## **DELWOOD PLACE SUBDIVISION**

Engineering Comments: FINAL PLAT COMMENTS (should be addressed prior to submitting the FINAL PLAT for review and/or signature by the City Engineer):

APPLICATION NUMBER 11 DATE July 18, 2019

# DETAIL SITE PLAN

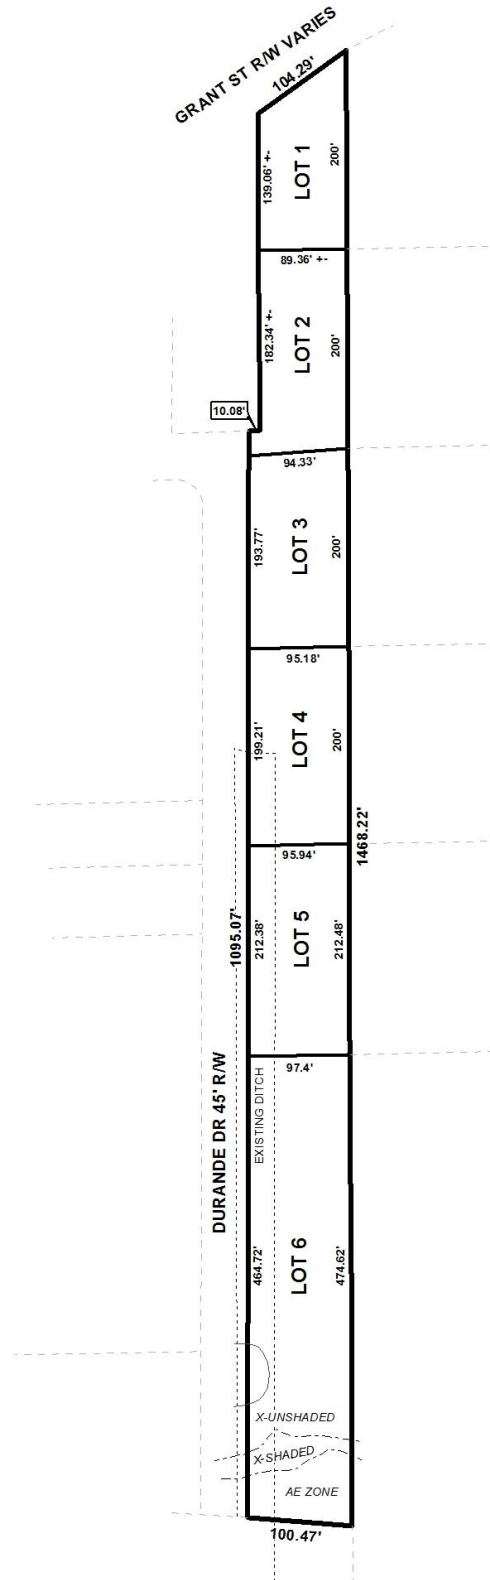
- B. Revise the ROW width shown on LOT 4-6 to match the ROW shown in the recorded Durande Court 1<sup>st</sup> Addition subdivision Plat – 35 feet instead of 45 feet.

- C. Provide recording information showing where and when the 10 foot wide PLANTING STRIP was dedicated to public ROW.
- D. The east line of the proposed subdivision indicates different CALCULATED bearings along the DELWOOD subdivision and the AF DELCHAMPS subdivision; however, the overall boundary line is CALCULATED to be on the same bearing. How can the newly set property corners exist along two (2) different property line bearings?

- E. Clarify whether the west property line is RECORD or CALCULATED.
- F. Revise the written legal description or the bearing and distance labels to match.

- G. Clearly show and label the bearing and distance of the 10.08 foot section at the southwest corner of LOT 2.
- H. Dedicate adequate ROW at the south end of Durande Drive for a cul-de-sac.

The current plat illustrates Durande Drive as having a 45' right-of-way. However, as outlined above, and referenced in the City Engineering comments, it appears Durande Drive has only 35' of right-of-way; therefore, dedication to provide a total of 25' from centerline will be required.

Lot 1 fronts Grant Street, and along this portion, Grant Street is considered to be a major street with a required 100' right-of-way. The plat depicts the right-of-way "varies"; however the plat should be revised to depict a 100' right-of-way, and provide 50' from center line.

Section V.D.9. of the Subdivision Regulations requires the provision of a 25' minimum building setback from the "front property line". The preliminary plat does not depict the 25' minimum building setback lines and thus, the plat should be revised to depict the 25' minimum building setback line after dedication.

It should also be pointed out that there appears to be a small existing turn around area where the proposed Lot 6 will be located. Based on the increased number of residential lots on the street, the increase in traffic, and the need to provide access for fire and garbage pick, a cul-de-sac turnaround should be required. It appears that a portion of Lot 6 should be dedicated for cul-de-

- 1) dedication and construction of a cul-de-sac turnaround at the end of Durande Drive, to be coordinated with and approved by Engineering, Traffic Engineering, and the Fire Department, prior to recording of the Final Plat;

- 2) dedication of adequate right-of-way along Durande Drive to provide 25' from centerline;
- 3) depiction of right-of-way along Grant street and if less than 100-feet, dedication of adequate right-of-way to provide 50' of right-of-way from centerline;

- 4) revision of the plat to depict the 25' minimum building setback line along all street frontages, after dedication;
- 5) retention of the lot sizes in square feet and acres;
